City of Santa Fe, New Mexico

memo

2025-010873-HDRB, 219 and 219 A Washington Ave, Downtown and Eastside Historic District, Contributing, Robert Evans, agent for Dennis Price, owner, requests approval for a 1,357 sq. ft. addition including a two-story structure to a height of 22'-0" at 219 Washington Ave and construction of a new 1,661 sq. ft. two-story structure at 219 A Washington Ave to a height of 24'-6" where the max allowable is 20'-1". Exceptions are requested to 14-5.2(D)(2)(d) an addition shall not exceed fifty percent of the square footage of the existing footprint and 14-5.2(D)(9) height.

Figure 3. 219A Washington Ave proposed new construction street facing façade.

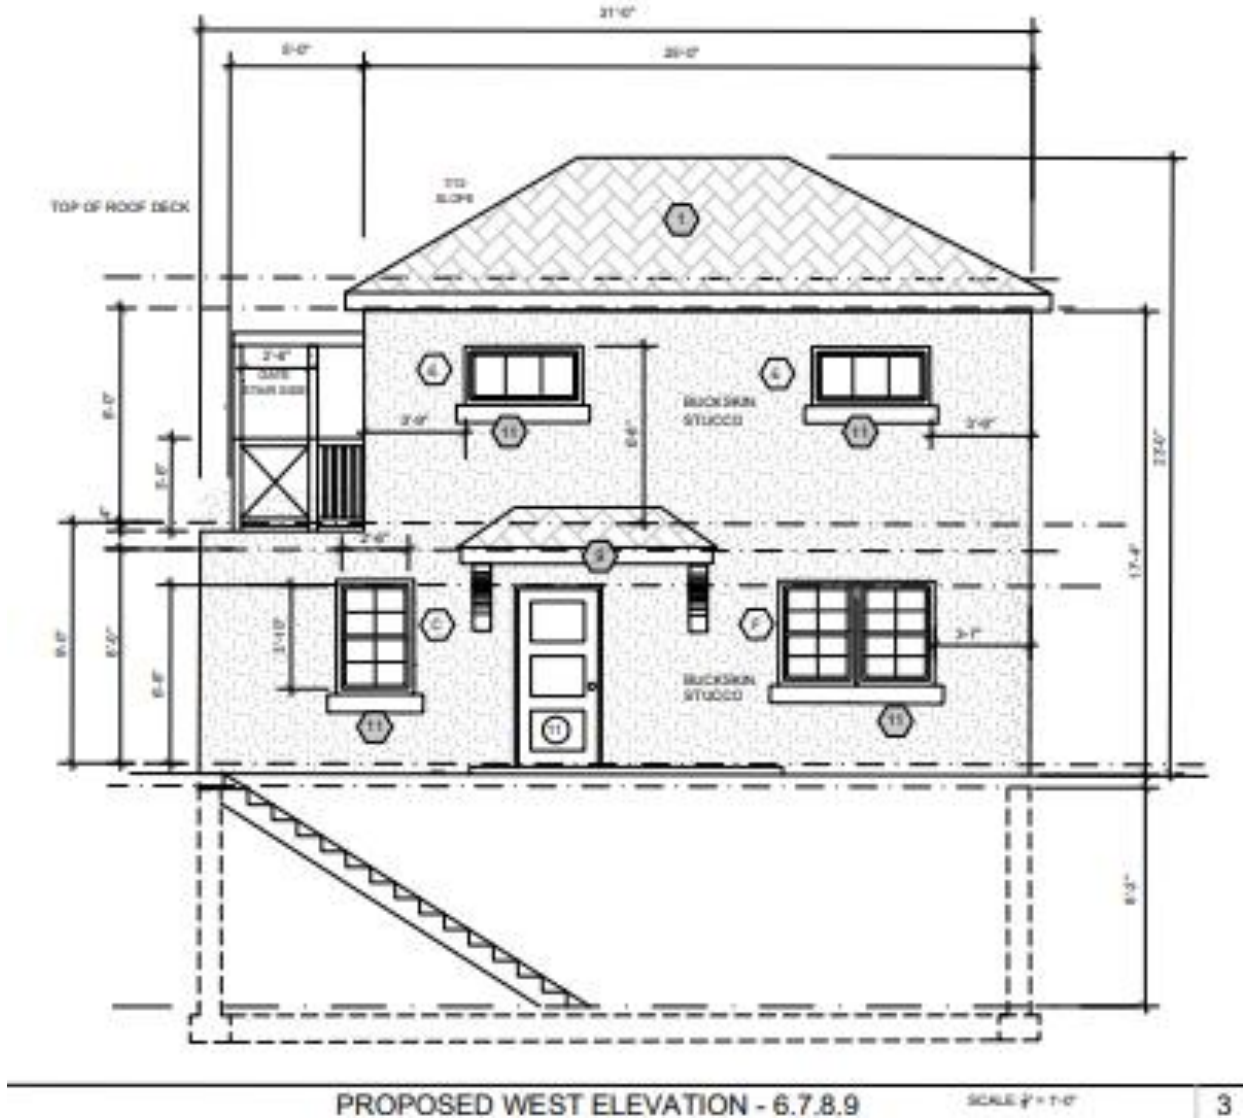
Exception to 14-5.2(D)(9) height: Staff requests an exception to 14-5.2(D)(9) for structures that exceeds the maximum allowable height of 20'-1" to 22' and 24'-6" respectively.

Staff Response: Staff has evaluated the applicant's response and finds that the criterion has been met. The proposed height of 22' at (219) and 24'-6" at (219A) is greater than the maximum allowable height of 20'-1" by 1'-11" to 4'-5" respectively. The adjacent two-story building at 215 Washington Ave is currently 29'-8" high. The variation of the proposed (219A)

Staff Response: Staff has evaluated the applicant's response and finds that the criterion has been met. The proposed height of 22' at (219) and 24'-6" at (219A) is greater than the maximum allowable height of 20'-1" by 1'-11" to 4'-5" respectively, however is 5'-2" shorter than the adjacent two-story building at 215 Washington Ave. The variation of the proposed (219A) will provide less of a visual impact on the streetscape and will not impact the contributing structures in the vicinity adversely given it will be stepped back to the east from Washington Ave.
